CHICK-FIL-A
POWERS & PALMER PARK
5813 PALMER PARK BLVD
COLORADO SPRINGS, CO 80915

GRADING, EROSION, AND SEDIMENT CONTROL PLANS

PCD FILE # PPR2521

CONSULTANT PROJECT #
PRINTED FOR
DATE: 01/31/2025
DRAWN BY: BRJ
SHEET: GRADING PLAN
SHEET NUMBER
C2.0

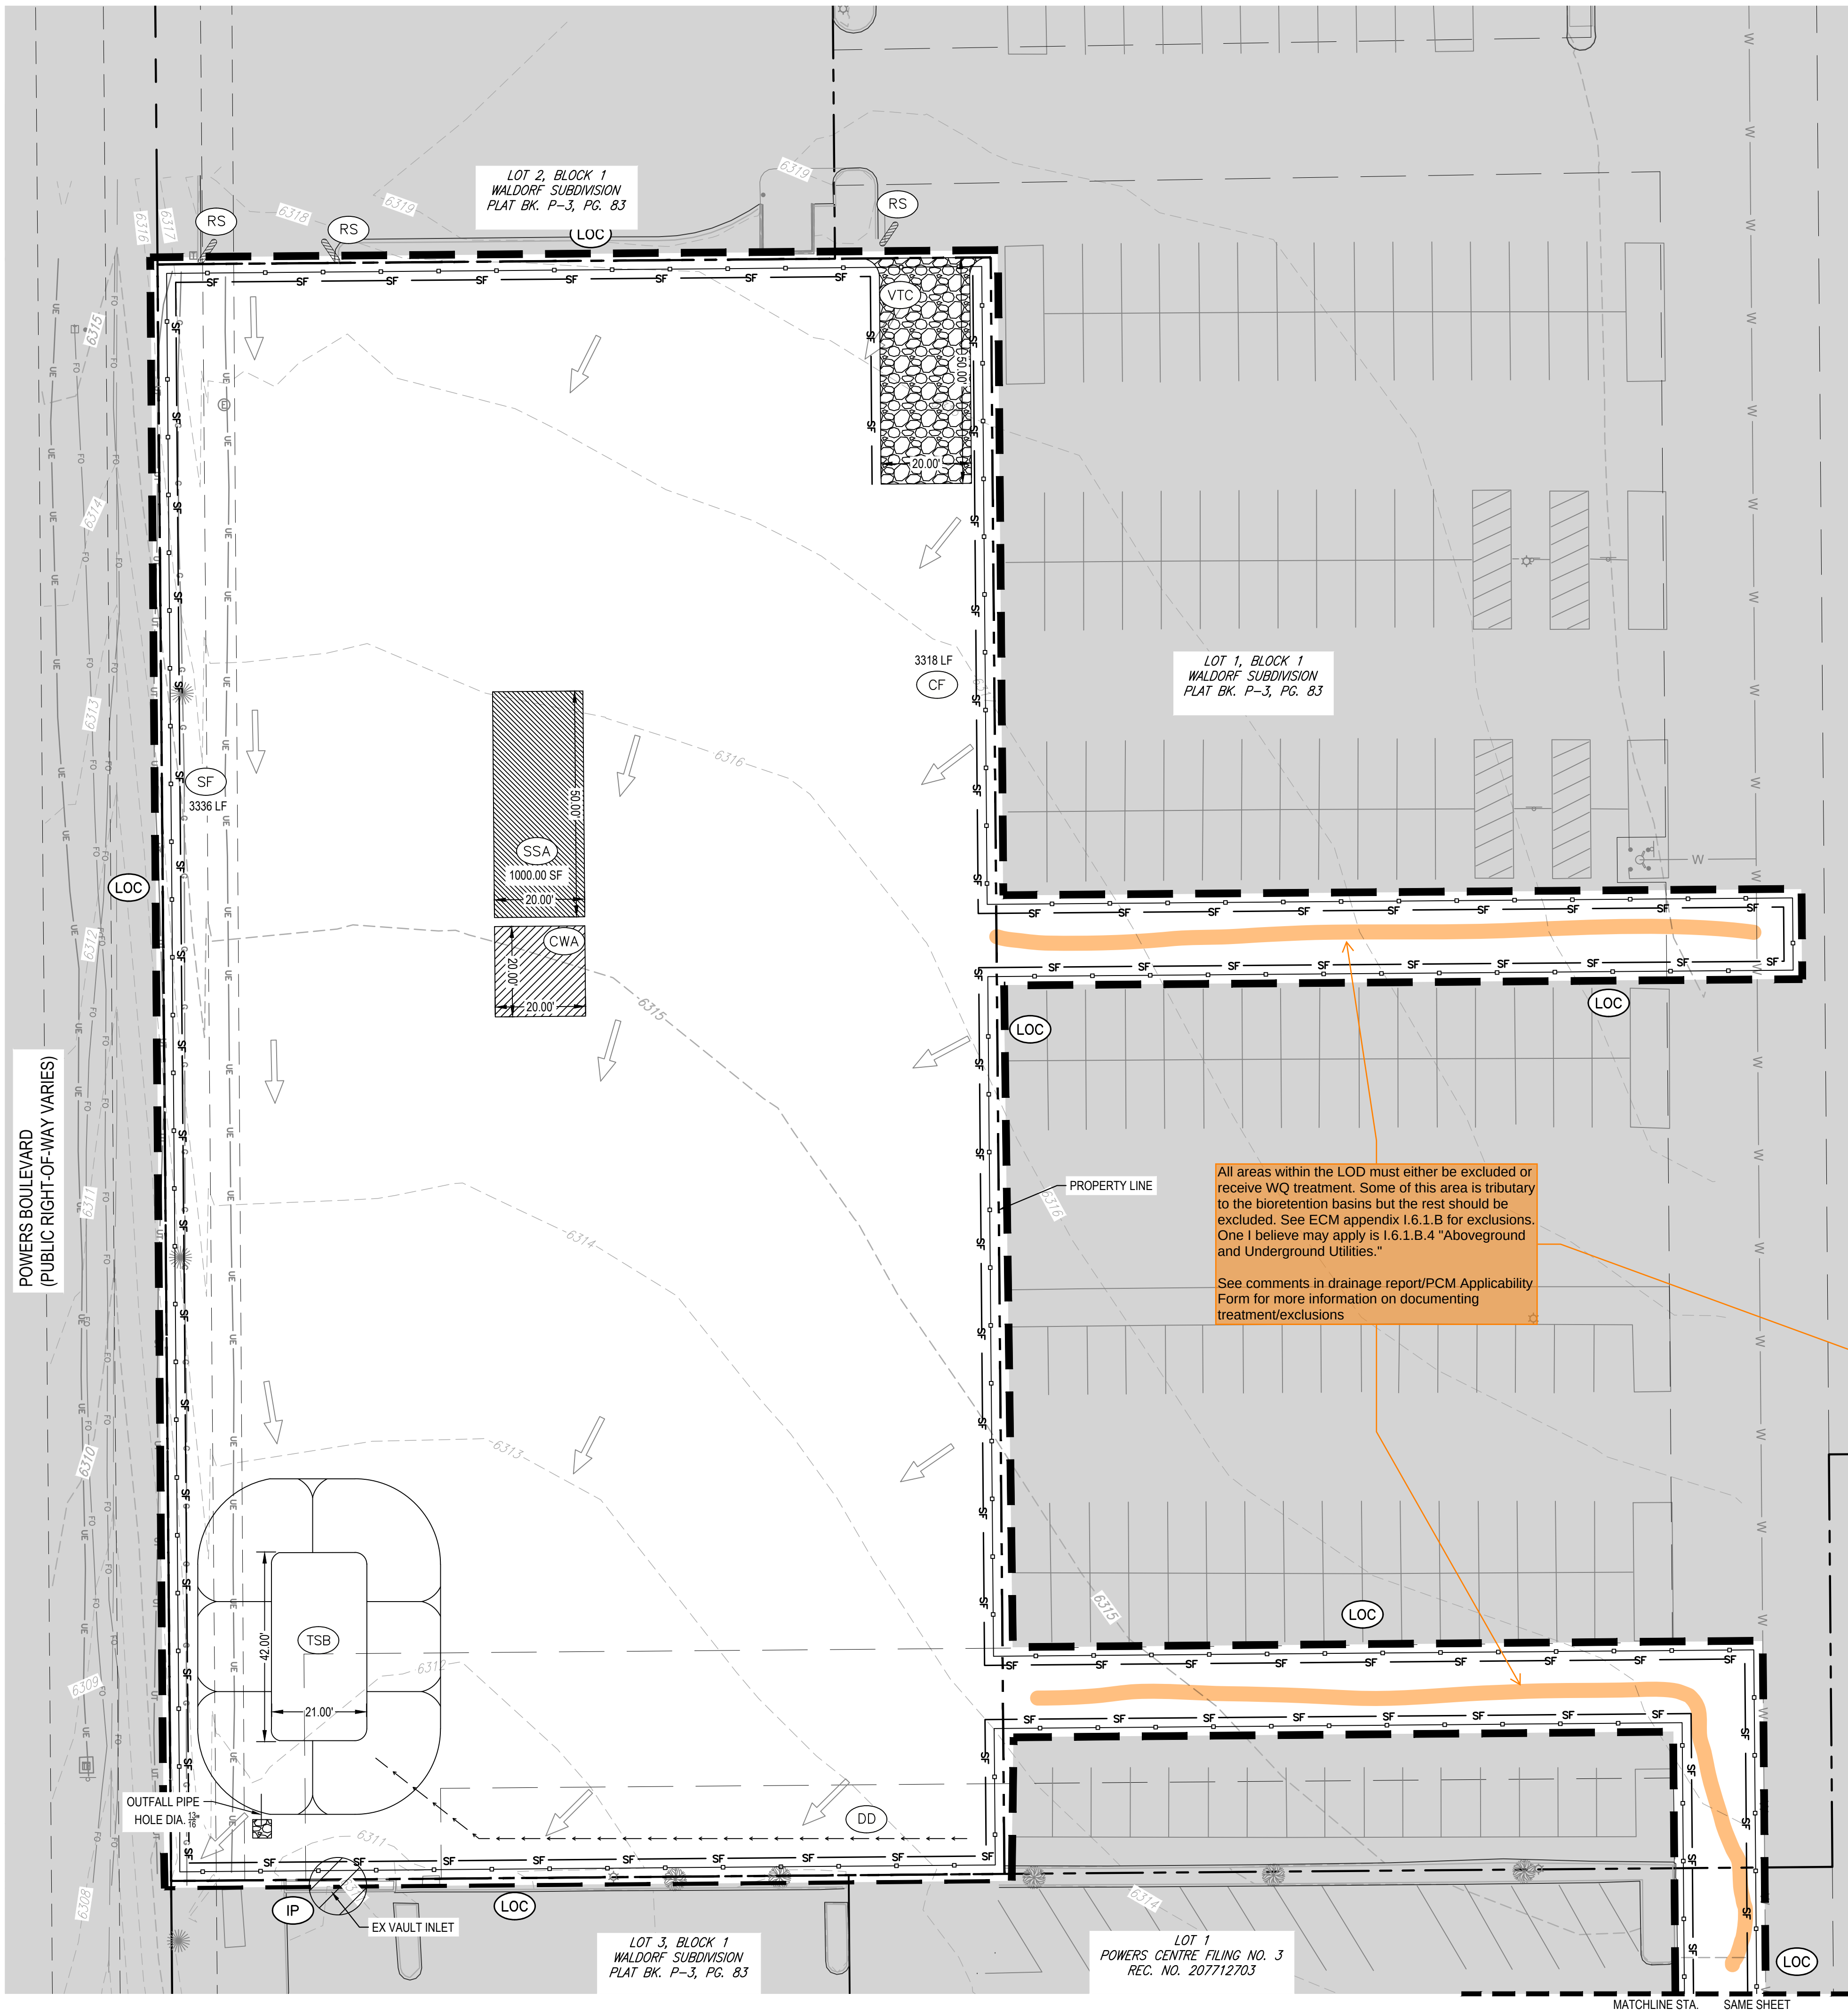
How will the bioretention basins pass larger storms? The calculations indicated that the WQCV will be infiltrated, but the larger storms will pass through these basins as well. Is the roadside ditch the intended outfall? Will armored spillways be provided?

Assign a name/number to all PCMs and then update all submitted text and drawings accordingly with consistent labeling throughout (example: "Pond A" or "Pond 1").
